# Technical Service Bulletin

SUBJECT:			No: <b>TSB-19-25-001</b>
<b>CORRECTION TO PROPELLER SHAFT ASSEMBLY REMOVAL PROCEDURE - SERVICE MANUAL REVISION</b>			DATE: <b>April 2019</b>
			MODEL: <b>See below</b>
<b>CIRCULATE TO:</b>	<input type="checkbox"/> GENERAL MANAGER	<input checked="" type="checkbox"/> PARTS MANAGER	<input checked="" type="checkbox"/> TECHNICIAN
<input checked="" type="checkbox"/> SERVICE ADVISOR	<input checked="" type="checkbox"/> SERVICE MANAGER	<input checked="" type="checkbox"/> WARRANTY PROCESSOR	<input type="checkbox"/> SALES MANAGER

This TSB updates the Propeller Shaft section of the affected Service Manuals, to correct the propeller shaft assembly removal procedure.

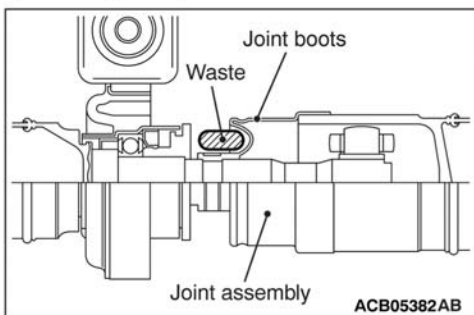
<Deleted>

<b>SPECIAL TOOL</b>			
<b>Tool</b>	<b>Number</b>	<b>Name</b>	<b>Use</b>
 MB991193	MB991193	Plug	Prevent the entry of foreign materials into the transfer case during removal of the propeller shaft.

#### PROPELLER SHAFT ASSEMBLY REMOVAL

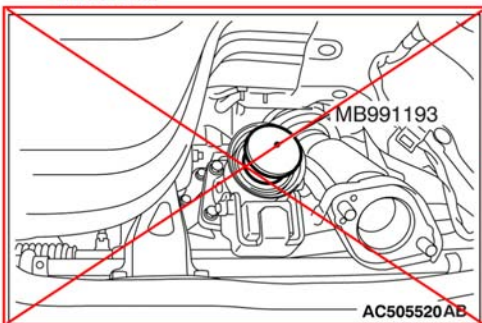
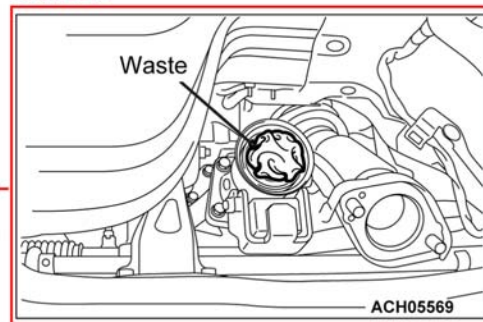
If the joint assembly is bent, it may be damaged when pinching the joint boots.

1. Insert a waste or similar materials into the joint boots, and remove the propeller shaft assembly by aligning the front propeller shaft with the rear shaft. **<Incorrect>**

**<Correct>**

**<Correct>**

**<Incorrect>**

2. Using ~~special tool plug (MB991193)~~, cover the transfer case to prevent the entry of foreign materials.

**a lint-free waste cloth**
